MECKLENBURG COUNTY
DEPARTMENT OF ENVIRONMENTAL HEALTH

APPLICATION FOR SOIL INVESTIGATION

RE: Property located at Plover Drive, Lot 58

SITE EVALUATION

**See Diagram on Back (includes: soil areas, property lines, roads, streams, gullies, wet areas, fill areas, wells, water bodies, slopes)

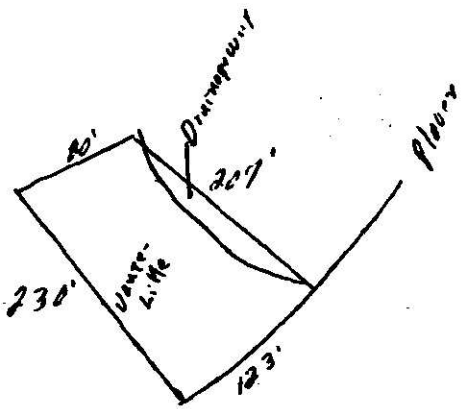
FACTORS	AREA 1	AREA 2	AREA 3	AREA 4
1. SLOPE (%)	S (PS) U 2%	S (PS) U 10-15%	S PS U	S PS U
2. SOIL TEXTURE (12-36 inches) Sandy, Loamy, Clayey (Note 2-1 Clay)	S PS — U	S PS 2-1 Clay U	S PS U	S PS U
3. SOIL STRUCTURE (12-36 inches)	S PS — U	S (PS) Blocky U	S PS U	S PS U
4. SOIL DEPTH (inches)	S PS — U	S PS 24-36" (U)	S PS U	S PS U
5. RESTRICTIVE HORIZONS (Inches) (Impervious strata, Rock)	S PS — U	S ± 36" PS (U)	S PS U	S PS U
6. SOIL DRAINAGE/GROUNDWATER (external and internal)	S PS Drainage-way (U)	S PS some infiltration of perched (U)	S PS U	S PS U
7. OTHER (Specify)	S PS U	S PS water table 24-30" U	S PS U	S PS U
8. SOIL GROUP	—	IVB		
9. SITE CLASSIFICATION	unsuitable	unsuitable		
10. SOIL SERIES	Drainageway	Vance-Like

Drainpoint
Property
207'
40'
230'
123'
Water Line
